I object to the whole of the WestConnex Project, and the specific WestConnex M4-M5 Link proposals as contained in the Environmental Impact Statement M4/M5 application, for the following reasons:

Name: Potricia Brown
Department of Planning and Environment GPO Box 39, Sydney, NSW, 2001	Address: 100 TERRY ST
Application Number: SSI 7485	Suburb: Tamie Postcode 2044
Application Name: WestConnex M4-M5 Link	Signature: P. Brown
Please include / delete (cross out or circle) my	personal information when publishing this submission to your website

The EIS states in 6.5.8 Darley Road civil and tunnel site (C4) that:

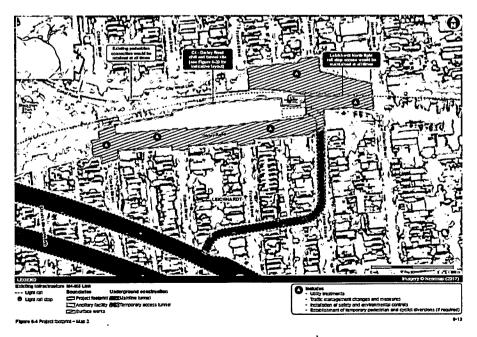
I object to the EIS because it fails to describe the temporary changes to Darley Road, Leichhardt to enable access to and from the ancillary facility that would likely be required in relation to the Darley Rd site and instead allows for the final plan to be decided by the contractor.

It is not clear how continued access, pedestrian and cyclist movement will be preserved and I am concerned that the impacts have not been correctly identified and assessed by the proponent.

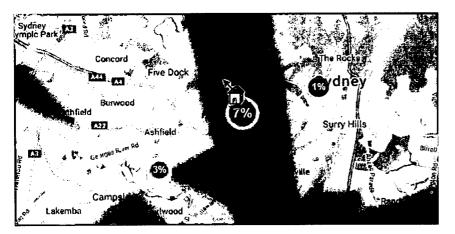
I object to the EIS because the proponent has failed to take account of the cumulative impact of emissions from spoil truck vehicles from it proposed Darley Road, Leichhardt civil and tunnel site operations and emissions from aircraft to which residents near the site are already exposed.

The attached extract from Webtrak shows that Darley Road, Leichhardt and adjacent streets are directly under the flight path.
